TRANS/WP.29/GRSG/2003/21  
25 July 2003

World Forum for Harmonization of Vehicle Regulations (WP.29)

PROPOSAL FOR DRAFT 02 SERIES OF AMENDMENTS TO REGULATION No. 107

(M2 and M3 vehicles)

"Figure 1 1/

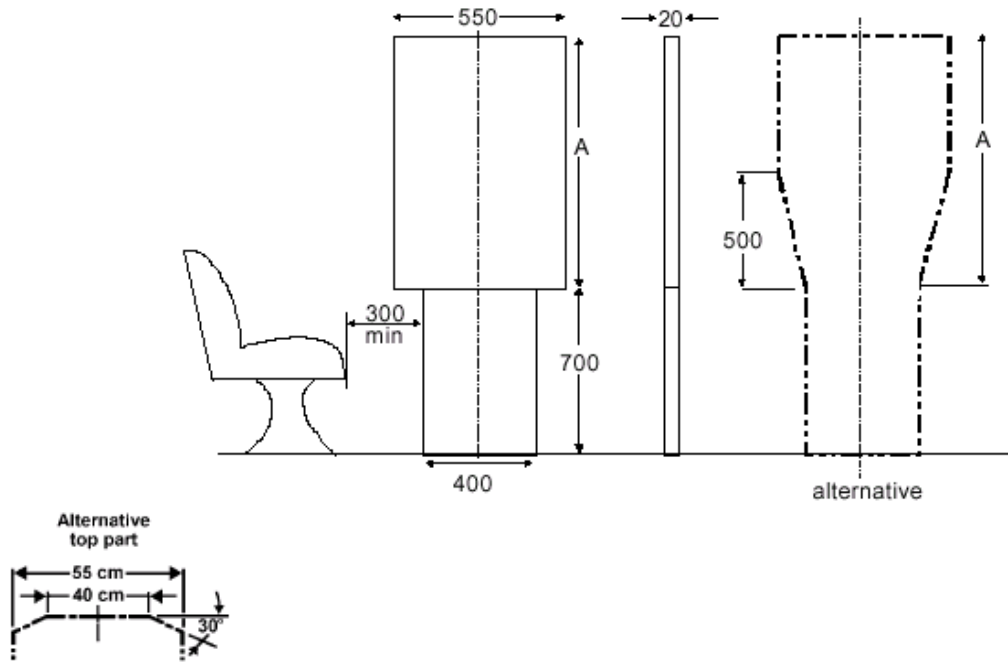
Figure 1, amend to read:

1/ "Alternative top part" diagram should be revised before publication to refer to "550 mm" and "400 mm" as appropriate."

Classes I, II and III: A = 1100 mm

Classes A and B: A = 950 mm

Number of passengers	≤ 22 (1)		> 22		
	A	B	I	II	III
Classes					
Dimension A (mm)	950	700	1100	950	850
Total height of dual panel	1650	1400	1800	1650	1550

"Figure 5

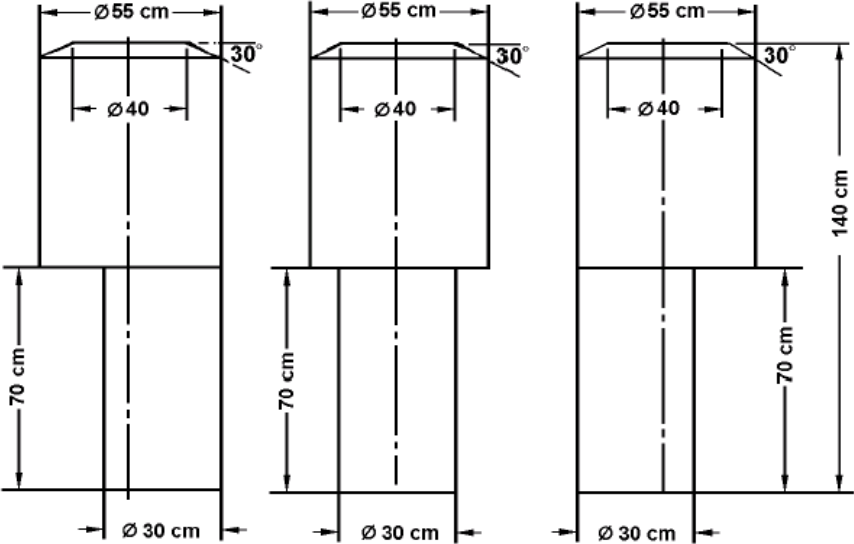
Figure 5, amend to read:

*[Editorial note: In final version, units should be changed to mm to align with text]*

"Figure 6  
GANGWAYS  
(see annex 3, paragraph 7.7.5.)

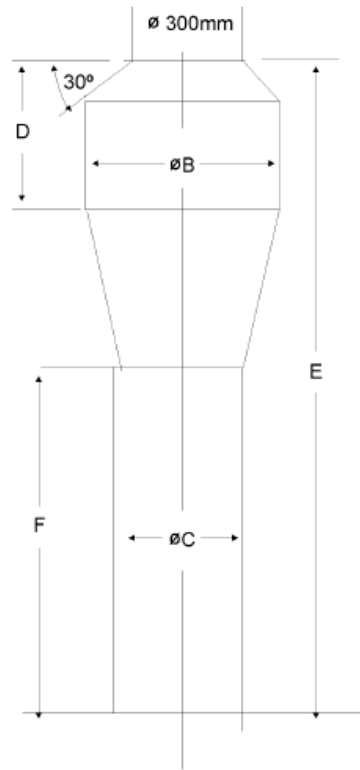
Figure 6, amend to read:

Single deck						
Class	B (mm)	C (mm)	D (mm)	E (mm)	F (mm)	
A	550	350	500 (4/)	1900 (4/)	900	
B	450	300	300	1500	900	
I	550	450 (3/)	500 (4/)	1900 (4/)	900	
II	550	350	500 (4/)	1900 (4/)	900	
III	450	300 (2/)	500 (4/)	1900 (4/)	900	
Double deck						
I	LD	550	450 (3/)	500	1800 (1/)	1020 (1/)
	UD	550	450(3/)	500	1680	900
II	LD	550	350	500	1800 (1/)	1020 (1/)
	UD	550	350	500	1680	900
III	LD	450	300 (2/)	500	1800 (1/)	1 020 (1/)
	UD	450	300 (2/)	500	1800	900

- (1/)** The overall height of the gauging device may be reduced (by reducing the height of the lower cylinder):
- a) from 1800 mm to 1680 mm in any part of the gangway of the lower deck to the rear of a transverse vertical plane situated 1500 mm forward to the centre of the rear axle (foremost rear axle in the case of vehicles with more than one rear axle),

- b) from 1800 mm to 1770 mm in the case of a service door which is situated forward the front axle in any part of the gangway situated between two transverse vertical planes situated 800 mm forwards and behind the centre line of the front axle.

- (2/)** 220mm in the case of laterally movable seats (see paragraph 7.7.5.3).
- (3/)** The diameter of the lower cylinder may be reduced from 450 mm to 400 mm in any part of the gangway to the rear of the most forward of the following two planes:

- (4/)** The height of the upper cylinder and herewith the overall height may be reduced by 100 mm in any part of the gangway to the rear of:
- a) a transverse plane situated 1.5 m forward of the centre line of the rear axle (foremost rear axle in the case of vehicles with more than one rear axle), and

"Figure 8

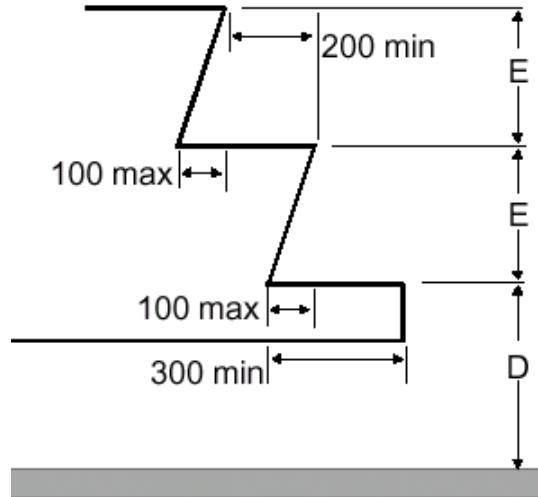
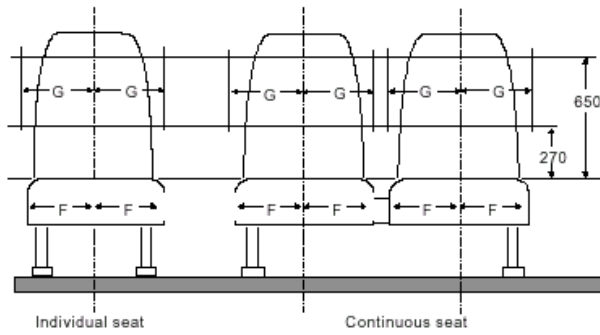
Figure 8, amend to read:

Classes		I & A	II, III and B
First step from ground 'D'	Max. height (mm)	340 (1)	380 (1)(2)(5)
	Min. depth (mm)	300 (*)	
Other steps 'E'	Max. height (mm)	250 (3)	350 (4)
	Min. height (mm)	120	
	Min. depth (mm)	200

**850 mm maximum in the case of an emergency door in the lower deck of a double-deck vehicle.**

Figure 9A

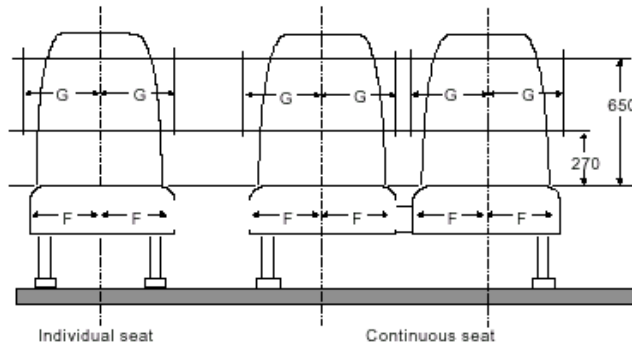
Figures 9 and 9A, amend to read:

G (mm) min	
F (mm) min	Continuous seats	Individual seats
200	200	200

"Figure 15

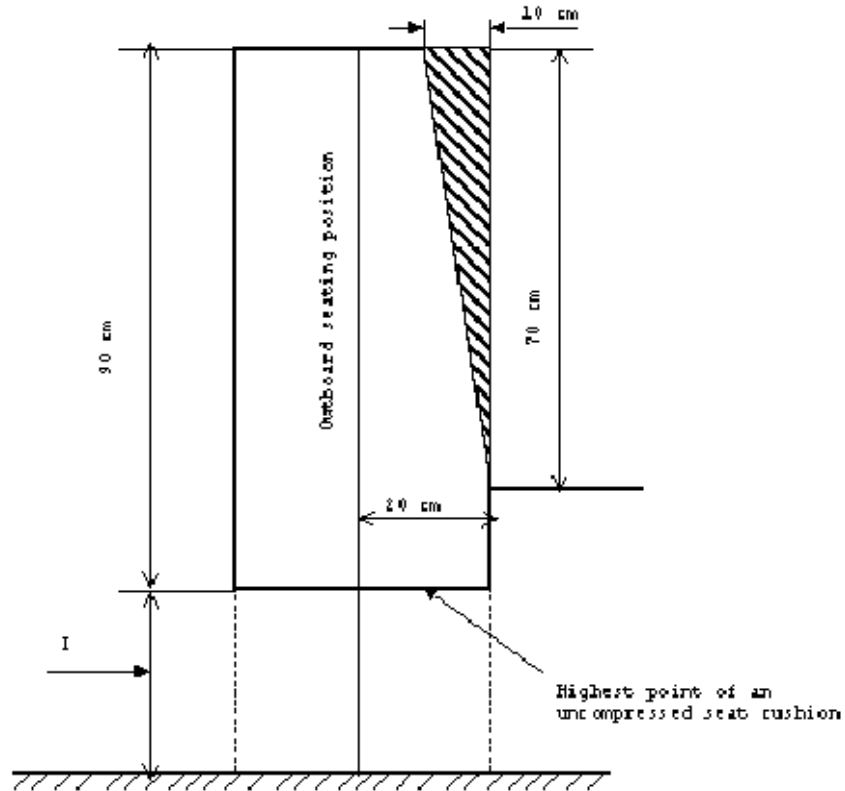
Figure 15, amend to read:

*[Editorial note: In final version, dimensions on diagram should be converted to mm]*

<b>I (mm)</b>
<b>400 to 500</b>
<b>(for classes A, B, I and II min 350 mm at wheel arches and engine compartment(s))</b>

"Figure 20

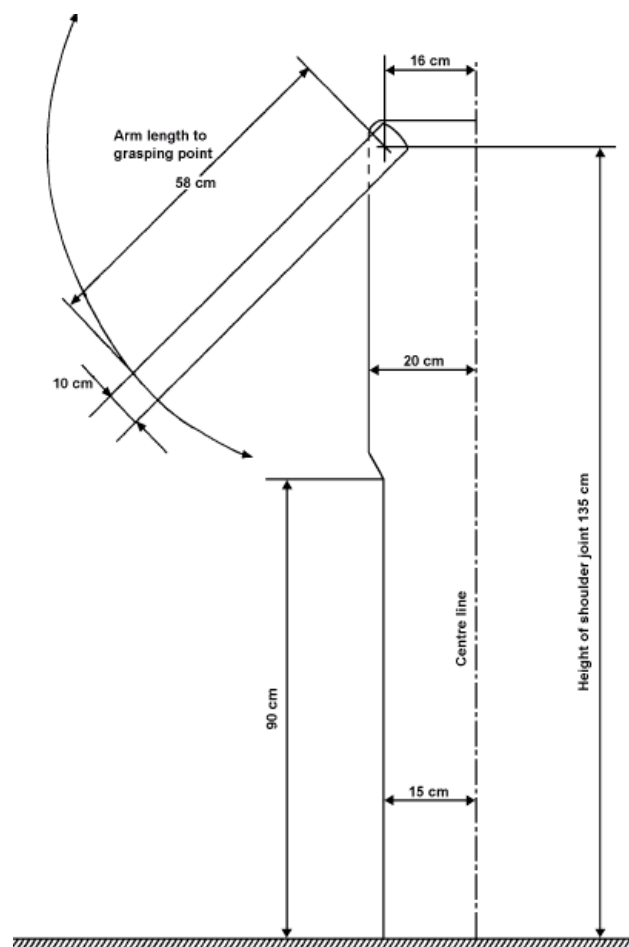
Figure 20, amend to read:

**Thickness: 2cm."**

**"Figure 24**

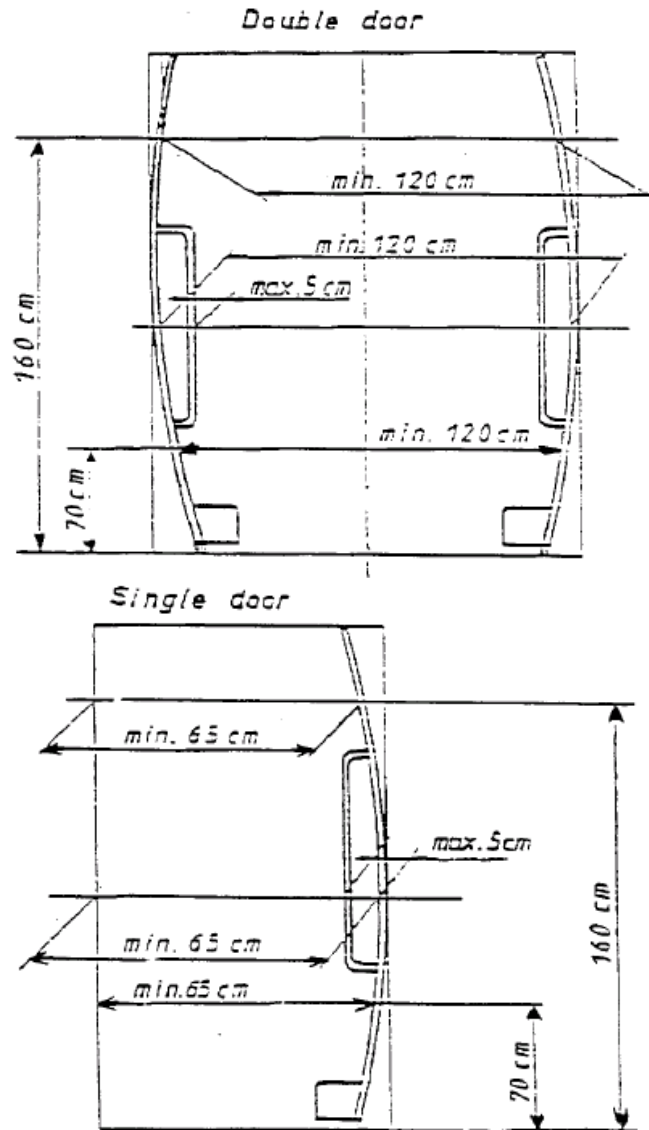
"7.6.3.1. The several kinds of exit shall have the following minimum dimensions **of free access (see also annex 4, Figure 24)**:

Insert new figures 24 to 26, to read:

**Figure 25**

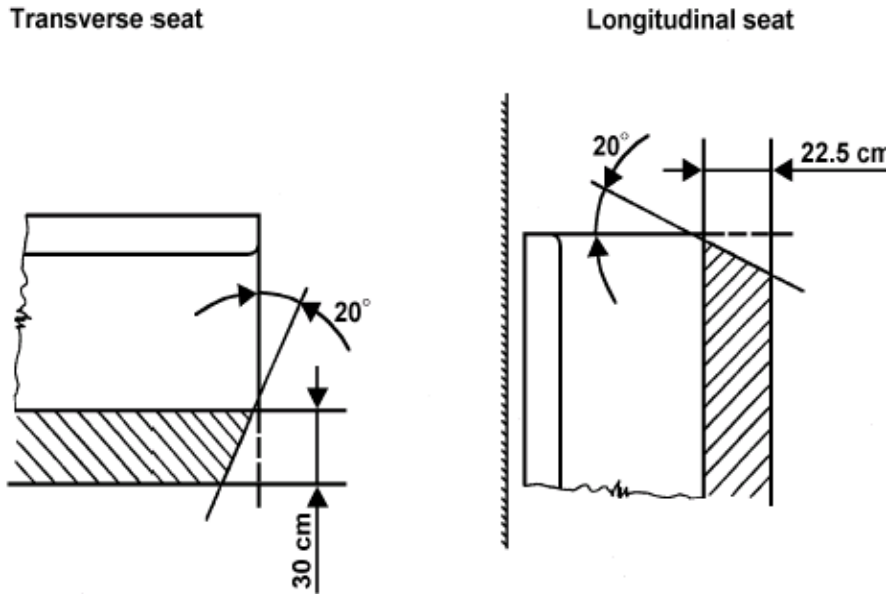
"2.15.1.            the space extending 300 mm in front of any seat, except where a sideways-facing seat is situated above a wheel arch, in which case this dimension may be reduced to 225 mm **(see annex 4, figure 25).**"

"7.7.1.6. The free passage clearance for this figure shall not include any space extending to 300 mm in front of any uncompressed seat cushion of a forward or rearward facing seat, or 225 mm in the case of seats fitted at wheel arches, and to the height of the top of the seat cushion **(see annex 4, figure 25)**."

**Figure 26**

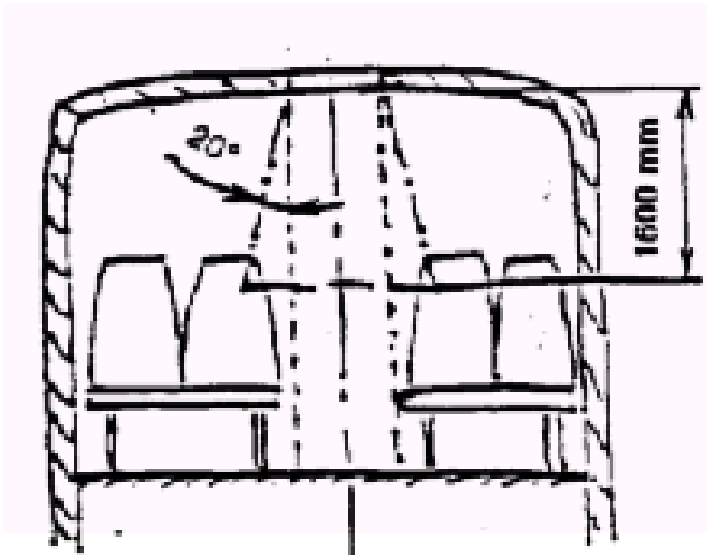
"7.7.4.1.1. Except in the case of Class I **and A** vehicles, at least one escape hatch shall be located such that a four-sided truncated pyramid having a side angle of 20 degrees and a height of 1600 mm touches part of a seat or equivalent support. The axis of the pyramid shall be vertical and its smaller section shall contact the aperture area of the escape hatch. Supports may be foldable or movable provided they can be locked in their position of use. This position shall be taken for verification."
